City of Pawtucket, RI

***** Addendum #2 *****

RFP # 13-063

Blackstone River Wall Repairs,

STABILIZED CONSTRUCTION ACCESS

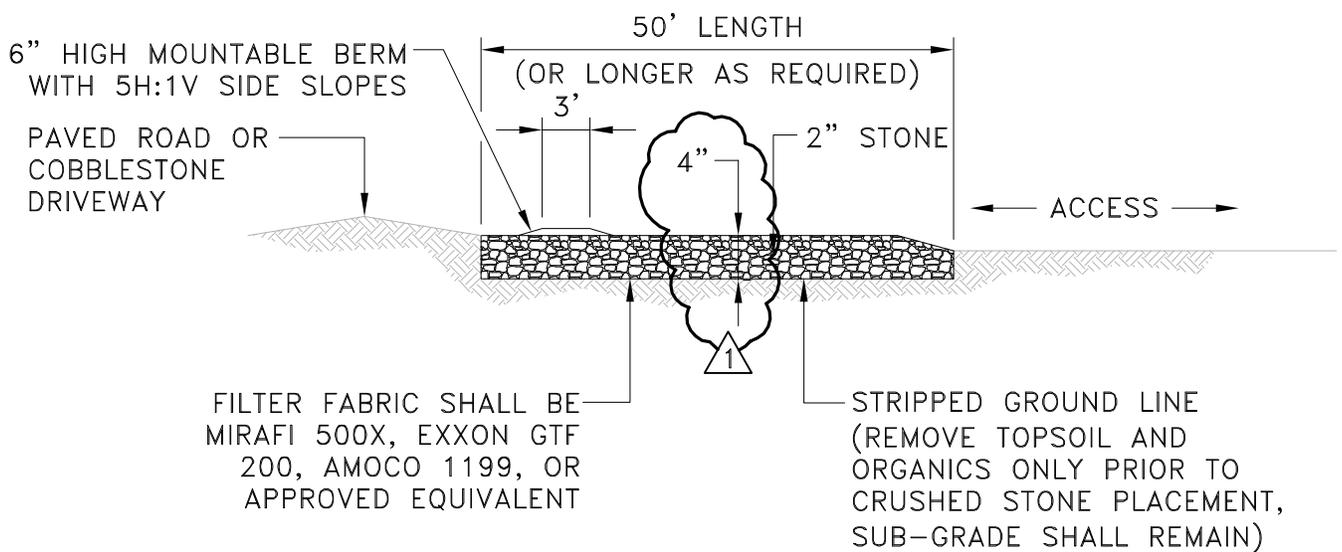
ITEM 2-1: Drawing No. C4.0 - Construction Management Plan, Stabilized Construction Access detail

DELETE: "Max." from stone thickness dimension call-off. See attached SKC-01.

A4: Yes, the Construction Entrances shall be constructed as Stabilized Construction Access per the detail on C4.0. Pavement shall be removed per Note #2 of this detail. This requirement shall also apply to brick sidewalks/walkways. Note the modification to depth call-off made by SKC-01 of this addendum.

BASE BID

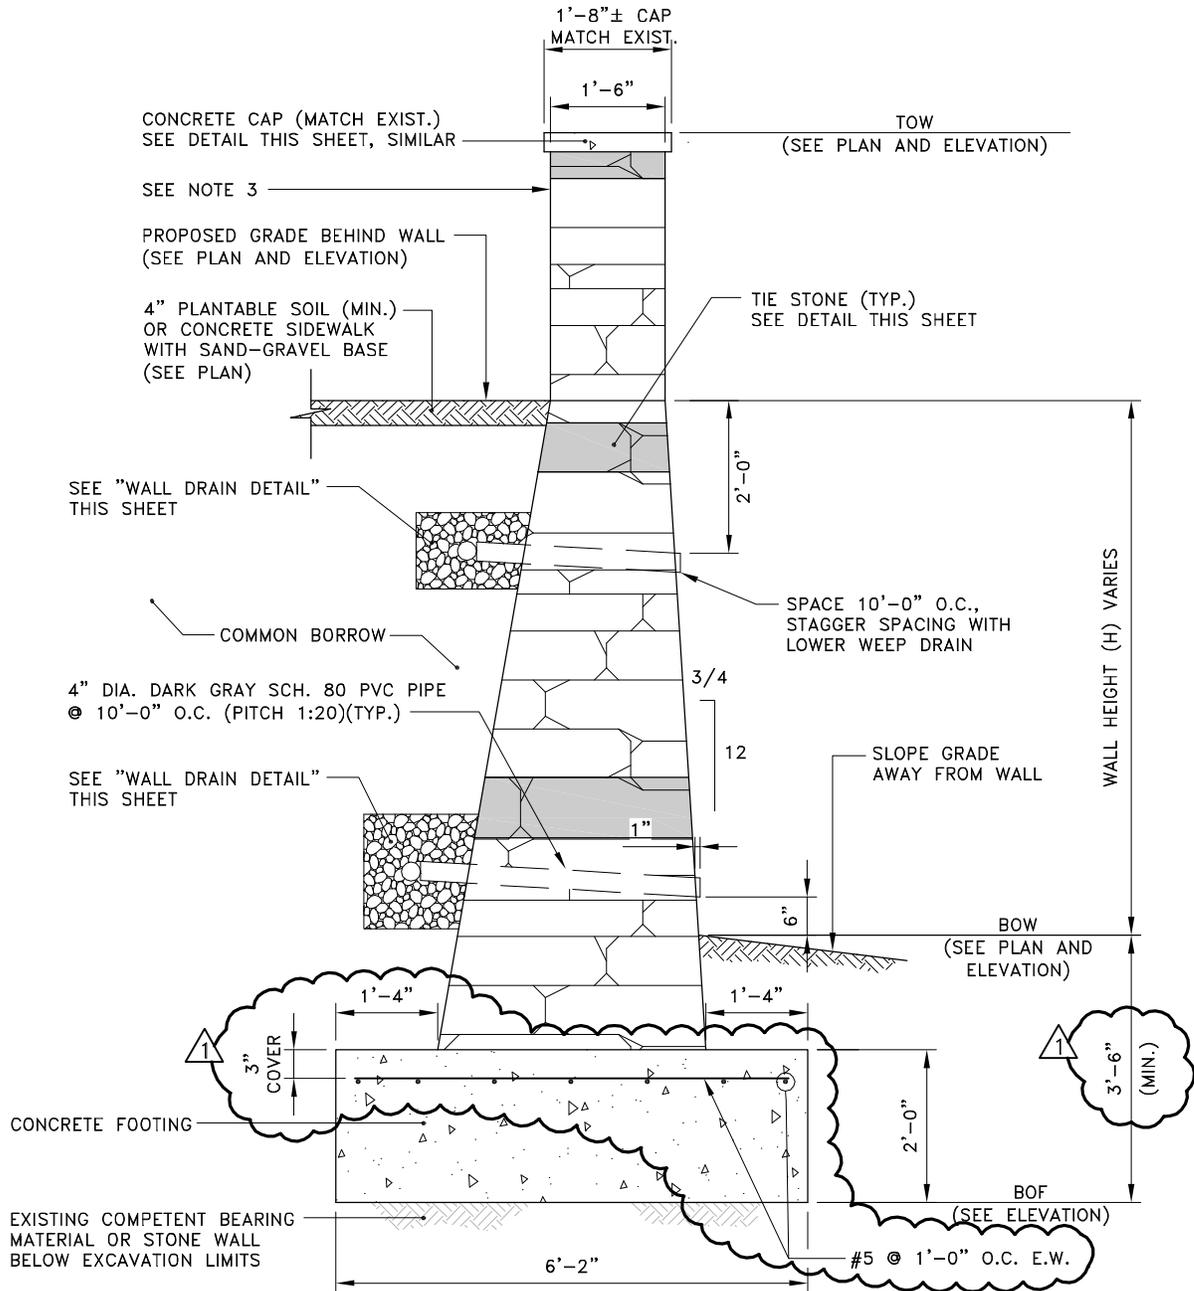
ITEM 2-2: Drawing No. C5.0 – Sections and Details, Section 2

ADD: 3" reinforcement cover call-off to Base Bid footing; #5@1'-0" o.c., each way, reinforcement in Base Bid footing; "Min." to 3'-6" dimension on Base Bid and Bid Alternate section. See attached SKC-02 & SKC-03.

BASE BID

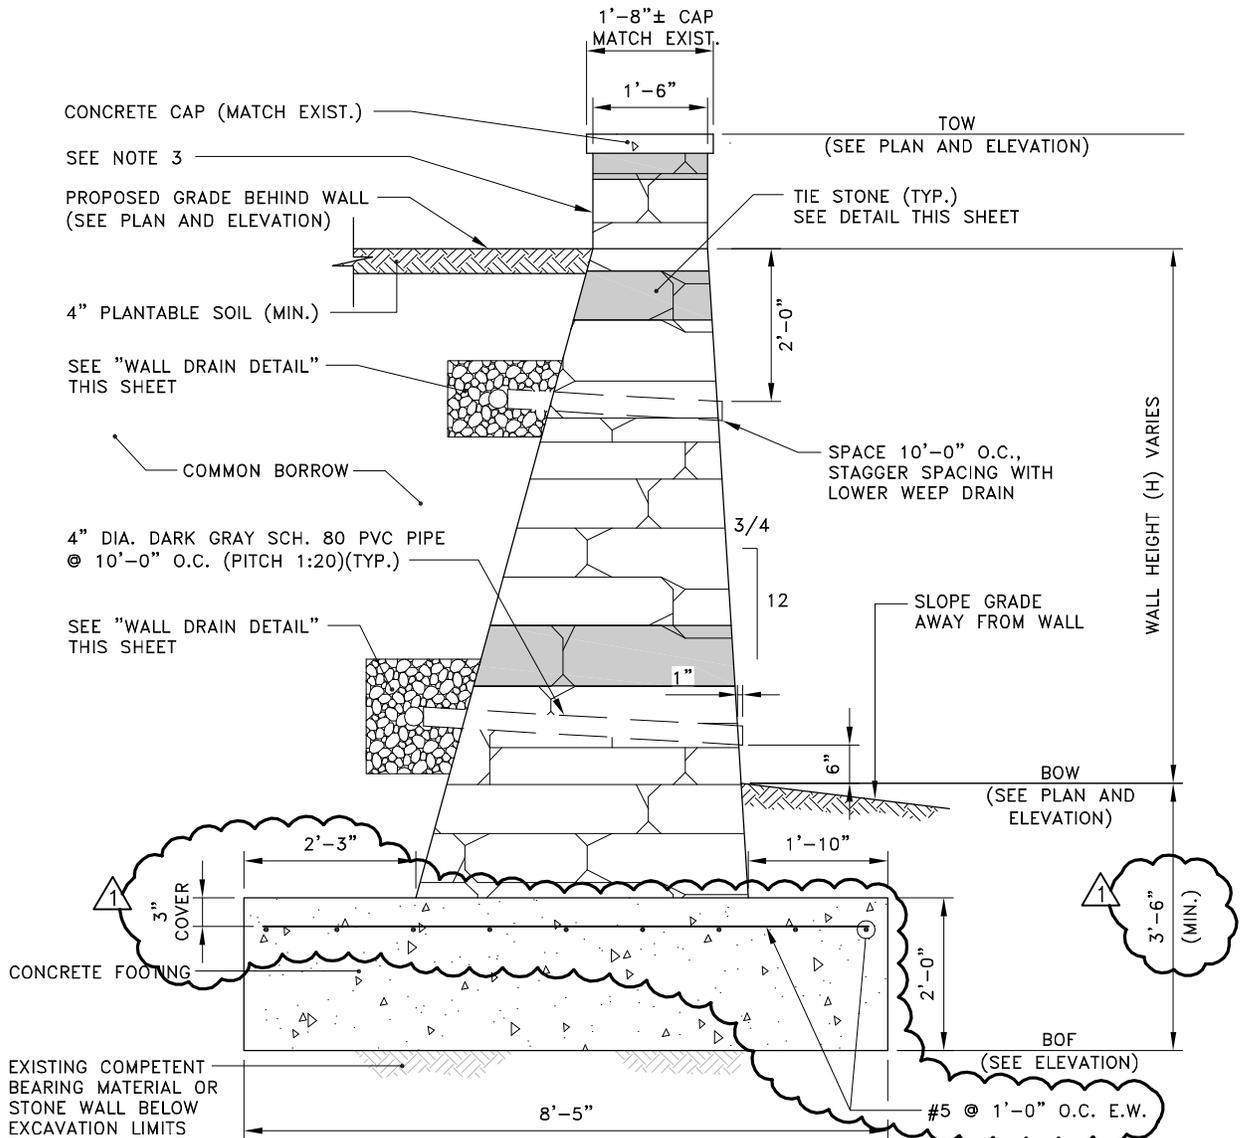
ITEM 2-3: Drawing No. C5.0 – Sections and Details, Section 3

ADD: 3" reinforcement cover call-off to Base Bid footing; #5@1'-0" o.c., each way, reinforcement in Base Bid footing; "Min." to 3'-6" dimension on Base Bid and Bid Alternate section. See attached SKC-04 & SKC-05.
